CITY OF ALBUQUERQUE

RE: 8004 Fuji Ct. NW
Grading and Drainage Plan
Engineer's Stamp Date: 2/15/25
Hydrology File: E10D088
Case # HYDR-2025-00041

Based upon the information provided in your submittal received 02/15/2025, the Grading & Drainage Plan is approved for Grading Permit (earthwork can get started for the earth pad on the house and retaining walls).

ENGINEER'S SEAL 	LOT 13 BLK 13 U 5 VC 8004 FUJI CT. NW	DRAWN BY DEM
	GRADING AND DRAINAGE PLAN	DATE 10-8-20
 1606 CENTRAL AVENUE SE SUITE 201 ALBUQUERQUE, NM 87106 (505) 872-0999		LOT 13 BLK 13 U 5 VC.DWG
		SHEET # C1
DAVID SOULE P.E. #14522		JOB #

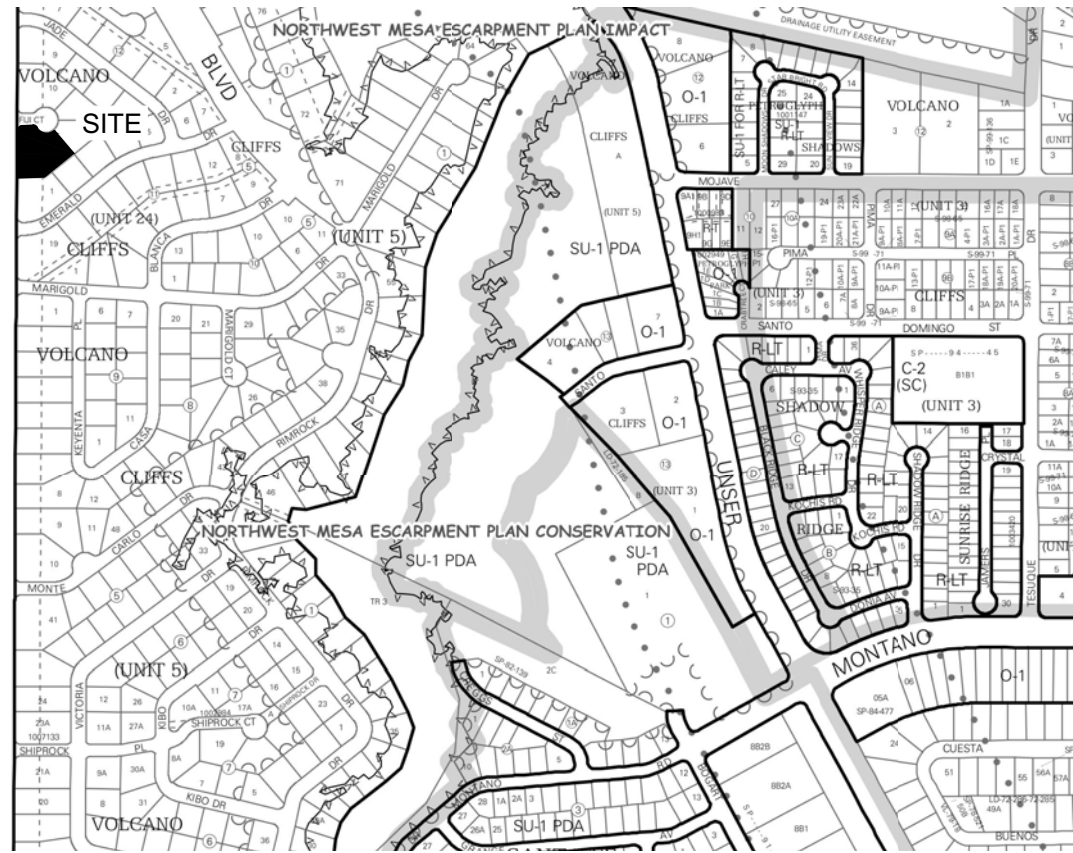
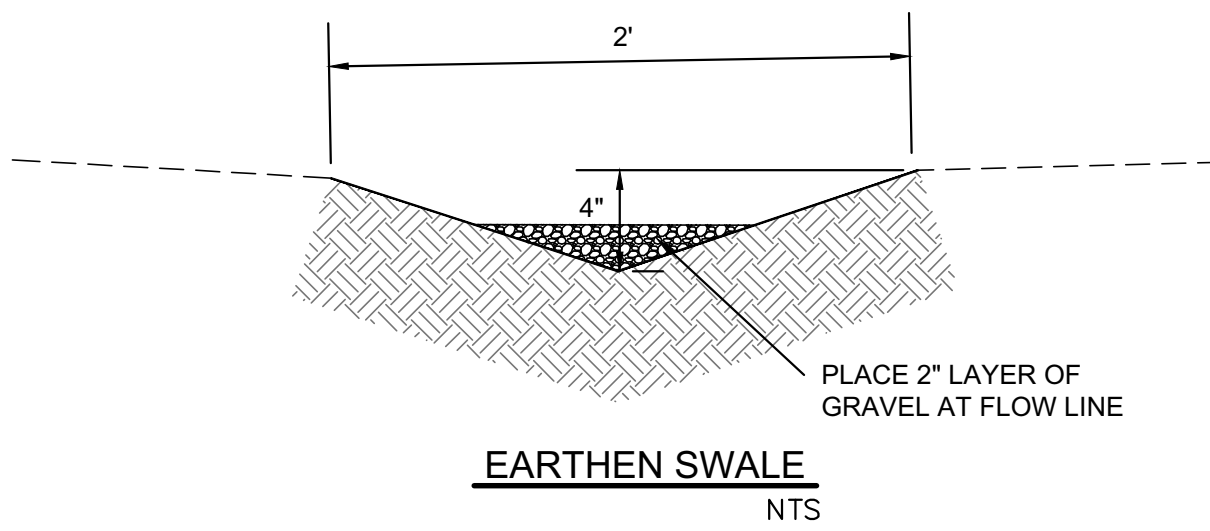
1. Once the grading is complete, a pad certification (meaning that the earthwork and retaining walls are complete) will be required.
